BALTIMORE GAS AND ELECTRIC COMPANY
DISTRIBUTION
SERVICES UNIT
P.O. BOX 1475
BALTIMORE, MARYLAND 21203

SUBJECT: Calvert Cliffs Nuclear Power Plant
Unit No. 1, Docket No. 50-317
Amendment to Operating License DPR-53
Fifth Cycle License Application
Responses to NRC Staff Questions

QUESTION 1X

FIGURE IX-6
CESEC - SLB
Pumps ON
REACTIVITY VS TIME

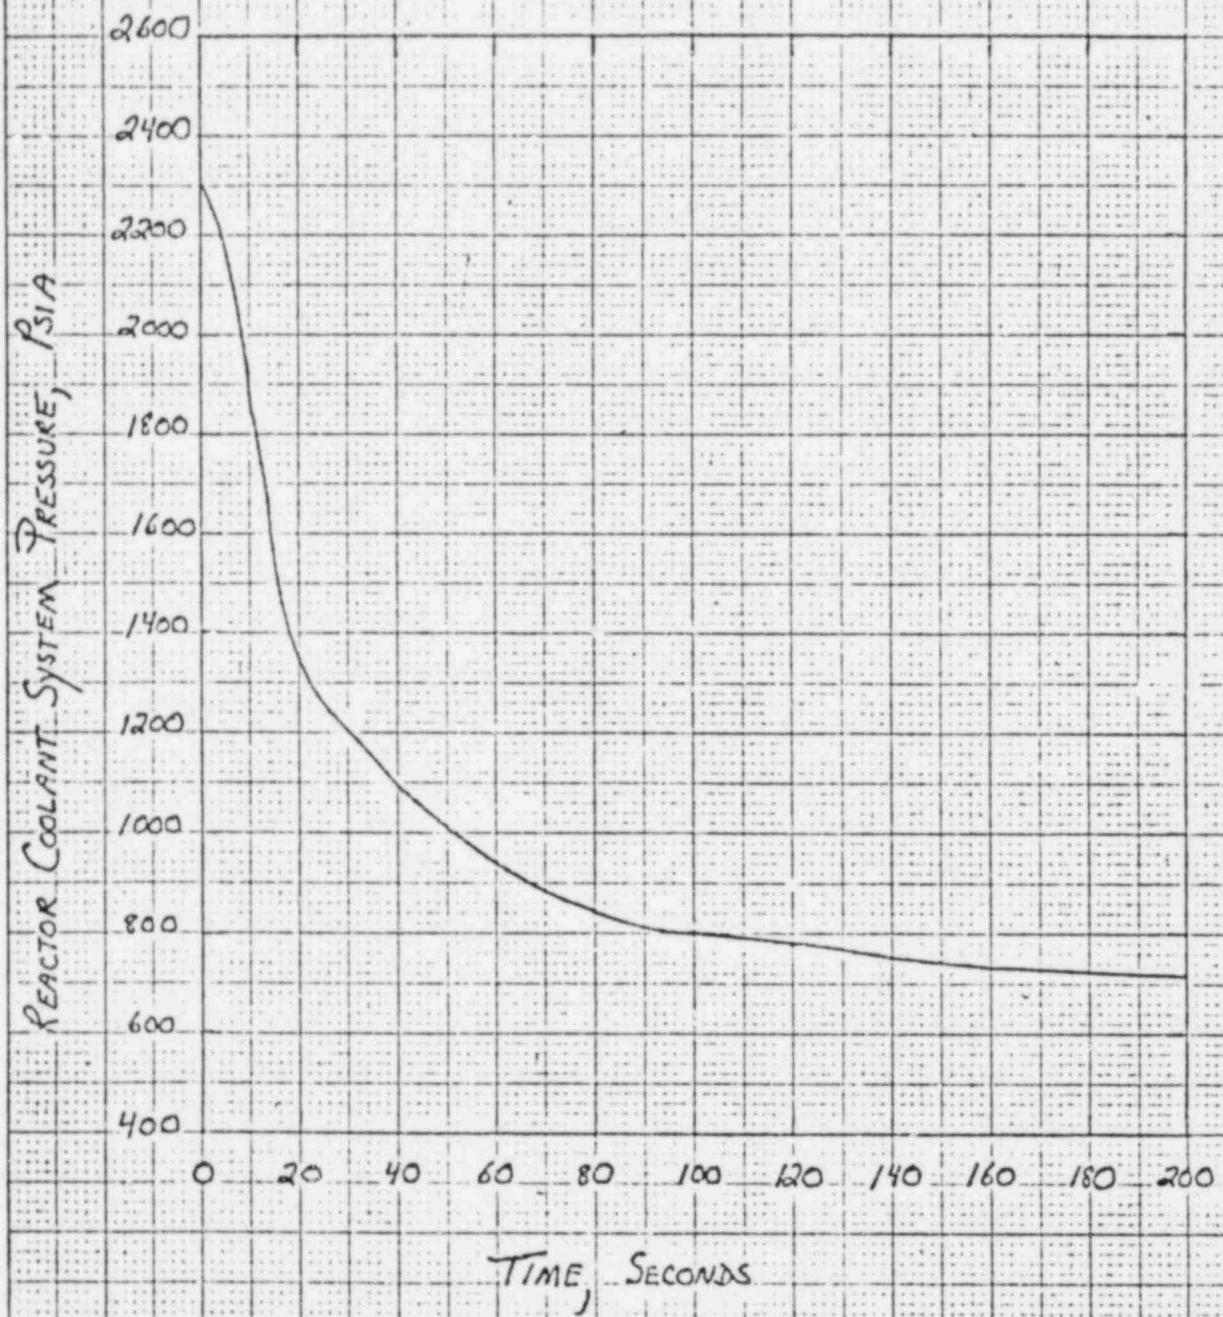
Provide comparative Steam Line Break analyses between CESEC-SLB and old version of CESEC. The comparison should include the following cases:

- a. CESEC-SLB with pumps off
- b. CESEC-SLB with pumps on
- c. old CESEC version with pumps off
- d. old CESEC version with pumps on.

Figures 1X-1 to 1X-5 present the NSSS response during a SLB event with RCP's off using the version of CESEC named CESEC-SLB.

1. The SLB event with RCP's off, analyzed with code version CESEC-SLB, determines the moderator reactivity feedback based on the cold edge inlet temperature. For all other SLB events presented the moderator reactivity feedback is calculated using the core average moderator temperature.

4. The limiting SLB event is with the RCP's off analyzed using the code version CESEC-SLB. This event is presented in the Calvert Cliffs Unit 1, Cycle 5 license submittal (Reference 1X-3).

5. The minimum DNBR for the limiting SLB event is greater than 1.6.
